CITY PLAN COMMISSION**THURSDAY, SEPTEMBER 5, 2024****FILE NUMBER:** S234-178**SENIOR PLANNER:** Hema Sharma**LOCATION:** Blue Ridge Boulevard, east of Cockrell Hill Road**DATE FILED:** August 8, 2024**ZONING:** PD 1116**PD LINK:** Not available.**CITY COUNCIL DISTRICT:** 3**SIZE OF REQUEST:** 5.215-acres**APPLICANT/OWNER:**

REQUEST: An application to create one 5.215-acre lot from a tract of land in City Block 6960 on property located on Blue Ridge Boulevard, east of Cockrell Hill Road.

SECTION 4
PRELIMINARY PLAT
S234-178
PALLADIUM ADDITION
LOT 1, BLOCK 6960
5.215 ACRES SITUATED IN THE
W.M. CROW SURVEY, ABSTRACT #238
CITY OF DALLAS, DALLAS COUNTY, TEXAS

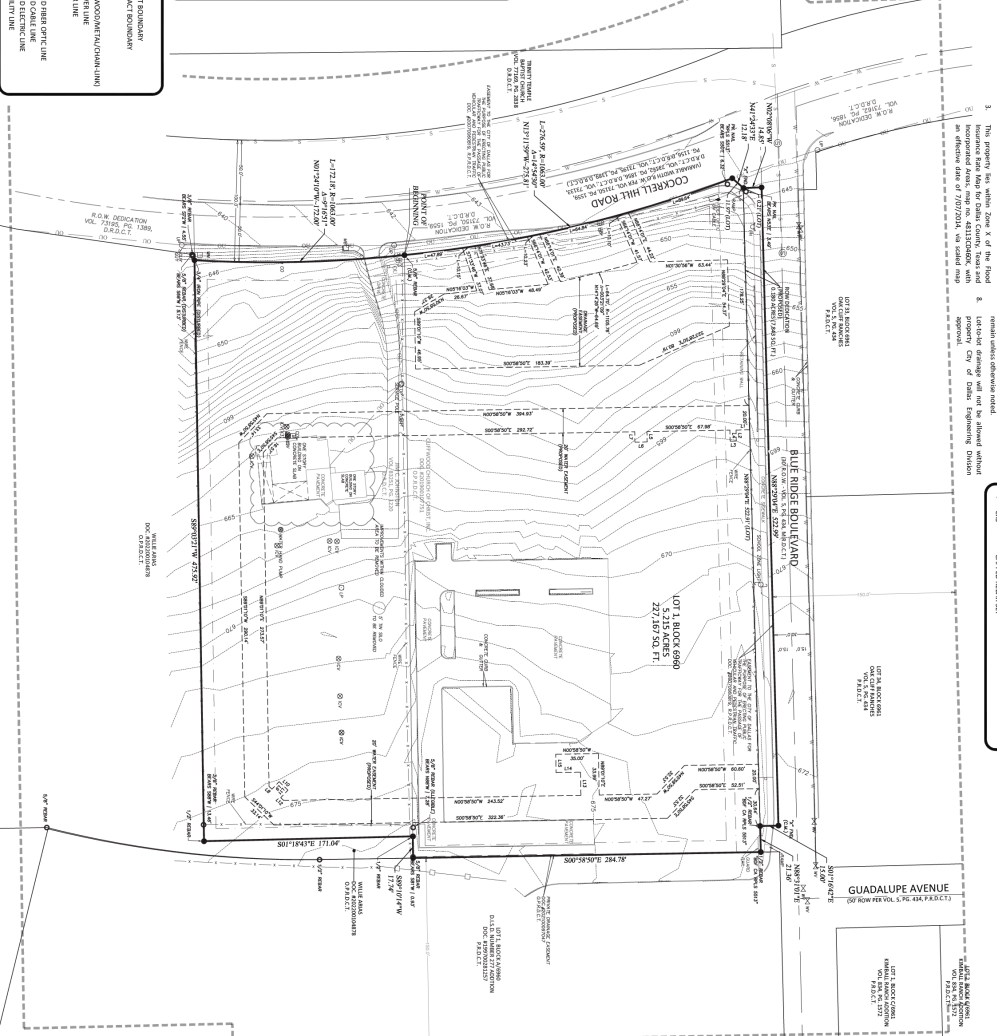
11. The number of lots permitted by this plat is one.

15. On the final plat, dedicate 50 feet of right-of-way (via fee simple) from the established center line of Cockrell Hill Road. *Section 51A 8.602(c)*
16. On the final plat, dedicate 28 feet of right-of-way (via fee simple or street easement) from the established centerline of Blue Ridge Boulevard. *Sections 51A-8.602(c), 51A-8.604(c) and 51A-8.611(c).*
17. On the final plat, dedicate a minimum 20-foot by 20-foot corner clip (via fee simple or street easement) at the intersection of Cockrell Hill Road & Blue Ridge Boulevard. Section 51A 8.602(d)(1)
18. A larger corner clip may be requested during engineering plan and traffic review to accommodate an adequate turning radius, or to maintain public/traffic

20. Prior to final plat, submit a completed final plat checklist and all supporting documents.
21. On the final plat, show recording information on all existing easements within 150 feet of the property.
22. On the final plat, show abstract line location.
23. Dedicate street easement in fee simple.

26. On the final plat, identify the property as Lot 2 in City Block A/6960.
